SUBJECT: Forwards addl info re inservice insp weld program. Revised pages to Table 1, Class 2 components welds to Table 2 for components & welds for which relief requested encl.

Donald C. Cook Nuclear Plant Unit 1
Docket Nos. 50-315 and 50-316
License Nos. DPR-58 and DPR-74
INSERVICE INSPECTION PROGRAM FOR WELDS - ADDITIONAL INFORMATION

ATTACHMENT NO. 1 TO AEP:NRC:0070H
(Revised Pages to Table 1 of Attachment B to AEP:NRC:0070G)

ATTACHMENT NO. 2 TO AEP:NRC:0070H
(Revised Pages to Table 2 of Attachment D to AEP:NRC:0070G)

Weld detail
LTP Ref. Number 008505

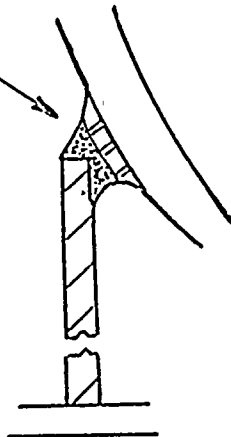
1. Attachment G, Page G-11, Item 2, Unit 2, Pressurizer to support skirt weld, LTP reference number 008505.
2. Attachment F, Page F-1, Units 1 & 2, Pipe to penetration weld covered by a whip restraint.

Weld between shell
and support skirt
